## **SERVICE BULLETIN**

### **SERVICE BULLETIN INDEX**

FIGURE 3

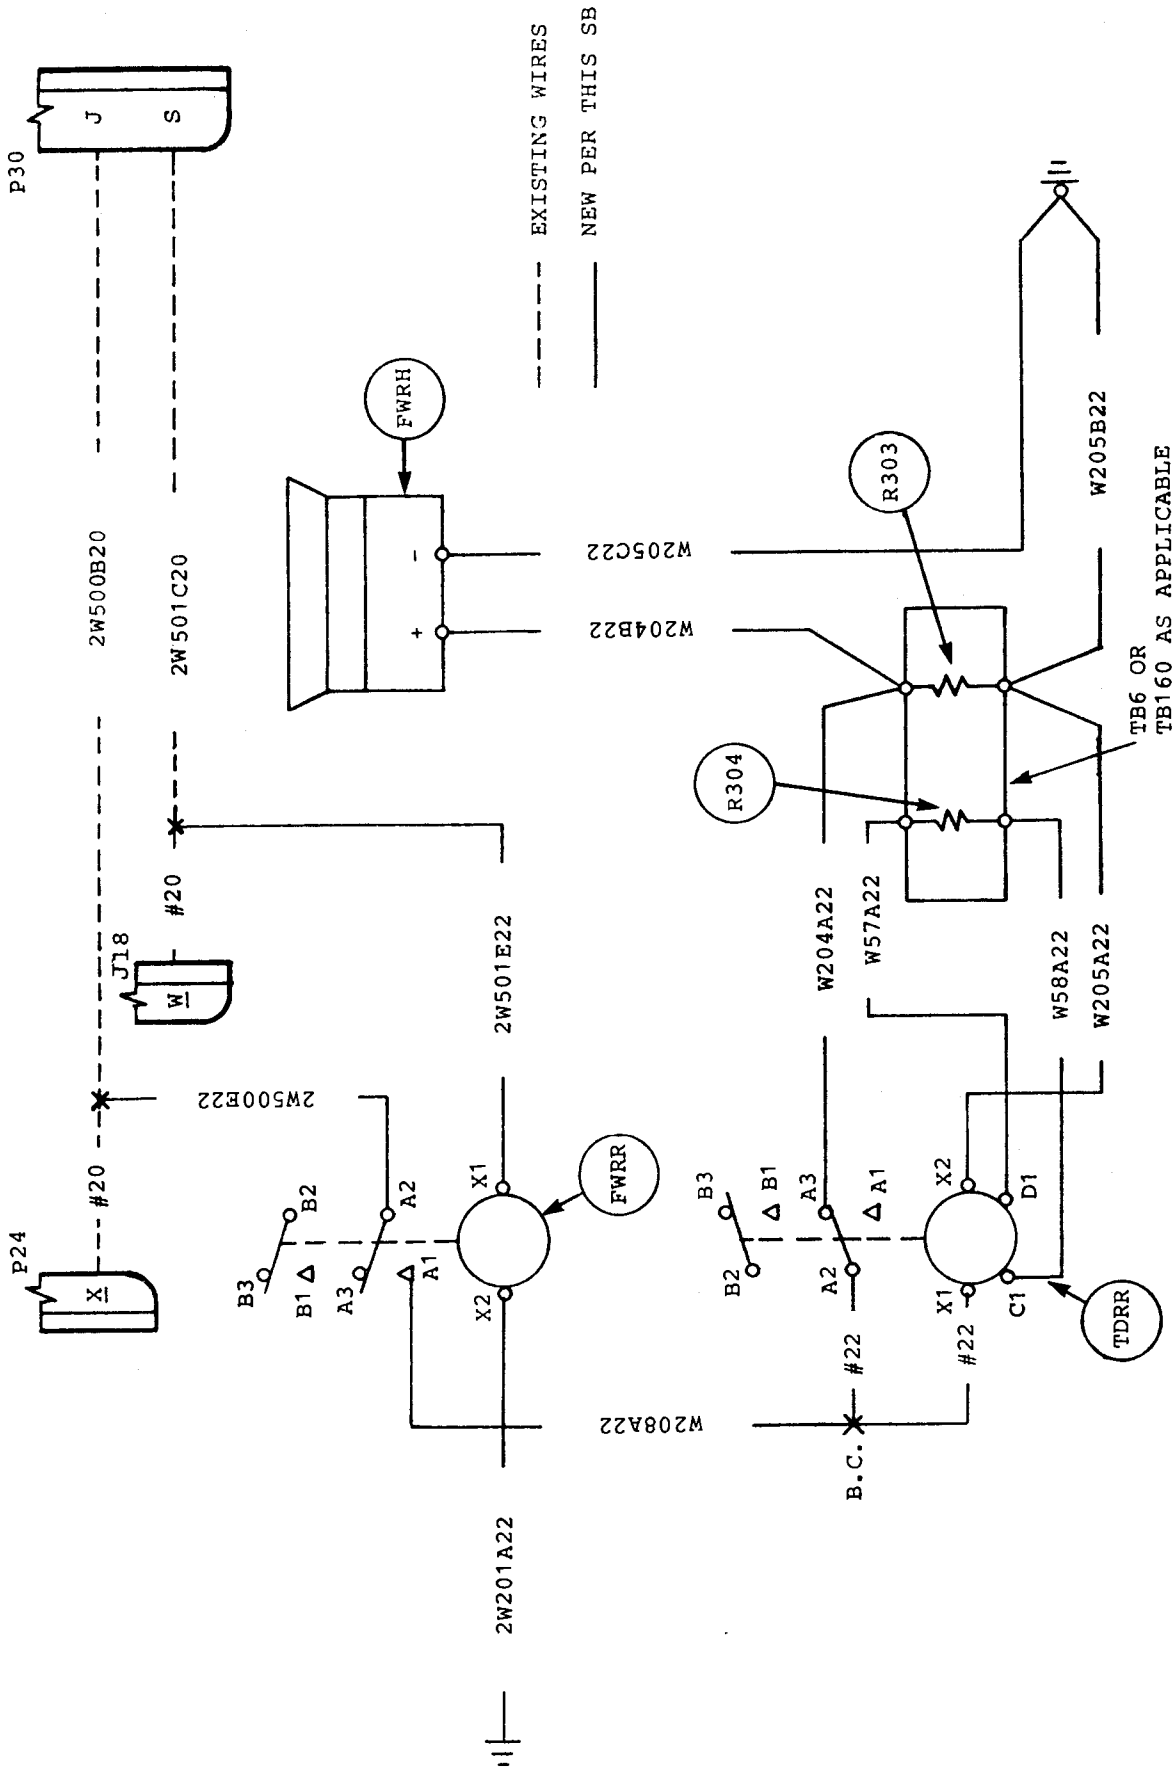
- (1) Complete all wiring as per Figures 2 and 3 (LHS and RHS, respectively), using standard shop practices.
  - (a) Plugs J49 and J18 are located on shelf aft of forward pressure bulkhead.
  - (b) Plugs P23 and P24 are located in the overhead panel (LHS and RHS, respectively).
  - (c) The terminal block is located and identified as per Figure 1 on the instrument panel support.

FIGURE 1  
CUTTING OF RUDDER SERVO TRIM TAB  
SHEET 1 of 2

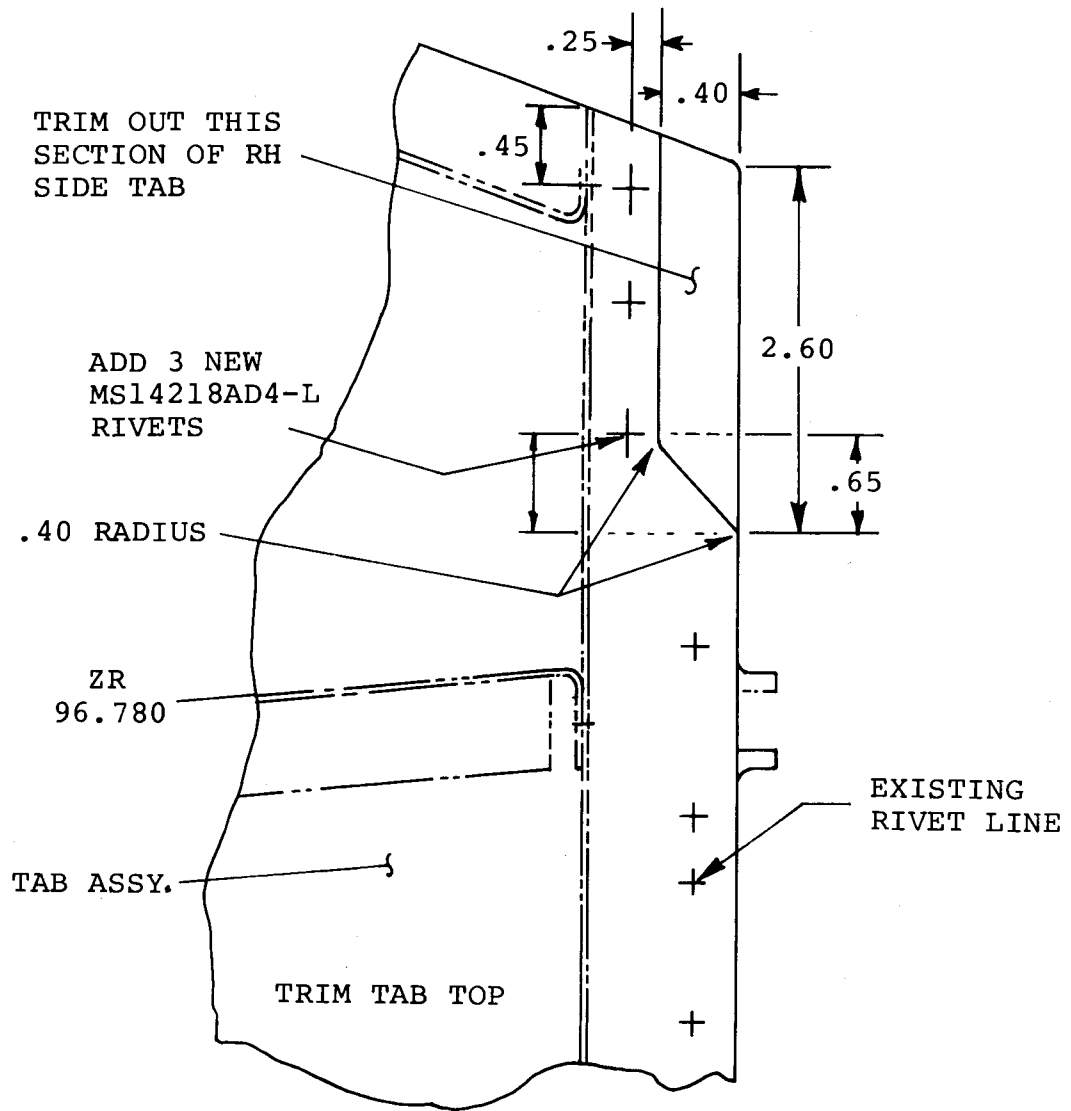
- A. Remove the rudder servo trim tab from the aircraft rudder in accordance with 1124/1124A Maintenance Manual, Chapter 27-20-00, removal/installation paragraph 3A.
- B. Layout area to be trimmed in accordance with Figure 1.
- C. (1) Before trimming off any material observe the proposed cutline for rivet edge distance to the spar radius and leading edge. If the edge distance on your rudder tab conforms to the measurements on Figure 1 utilize the rivet pattern reflected in Figure 1 to effect the modification.

Make sure that a minimum of 2D (.25) edge distance from center of rivet hole shall be maintained after cutting out completely the existing 1/8 rivet holes in a straight line as shown in Figure 1.

- (2) If the remaining edge distance results in less than those measurements reflected in Figure 1, go to Figure 2.
- (3) Since edge distance determines rivet size and quantity, it is important that the number of rivets in Figures 1 and 2 be used to maintain integrity of the tab leading edge. Select the rivet pattern that will best suit the required number to accomplish the modification.

- D. Using pilot holes and CLECO fasteners as required, trim off material assuring corners have proper radius and edge distances are maintained.
- E. Locate and install new rivets (in accordance with Figure 1 or Figure 2) that best match the edge-distance remaining after the cut is made.
- F. Touch up or repaint trim tab assembly as required.
- G. Reinstall rudder servo trim tab in accordance with 1124/1124A Maintenance Manual, Chapter 27-20-00, Installation, paragraph 3.B.

FIGURE 1

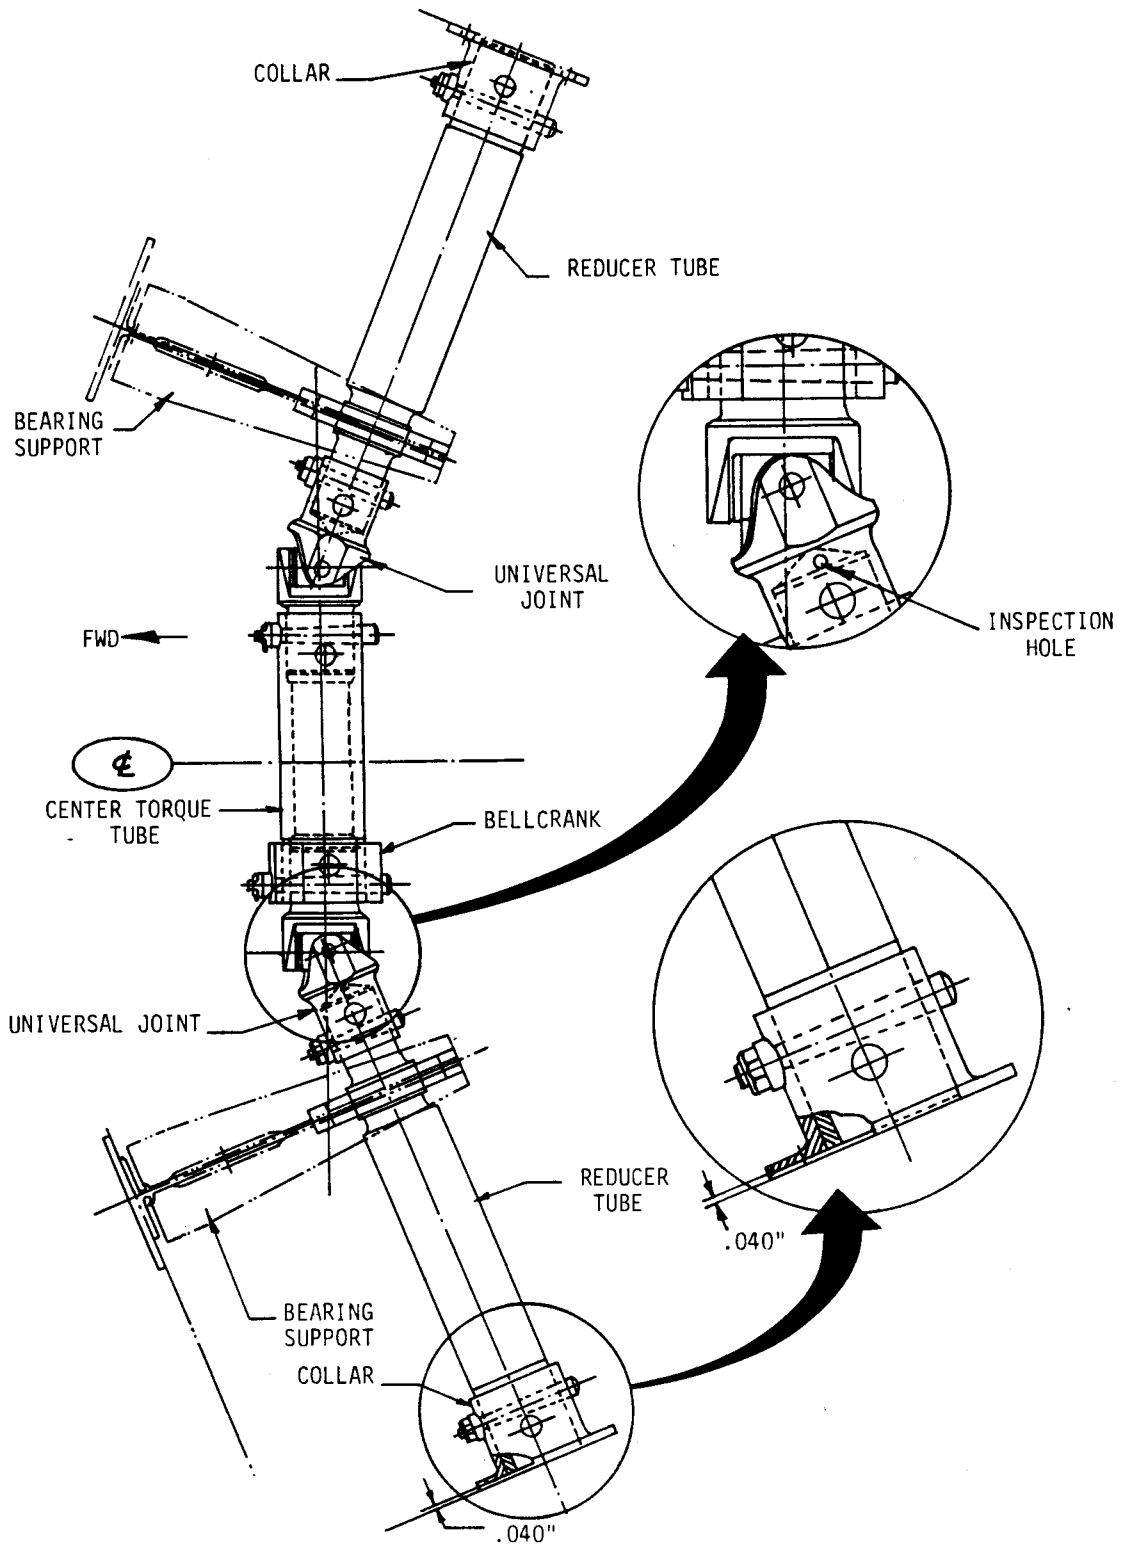
- C. Perform dye-penetrant inspection in radius of both collars (reference Figure 1).
- D. If no defects, proceed to step E. Defective collars must be replaced with a new reducer tube P/N 3533579-501 and collar P/N 3533577-1 as follows:
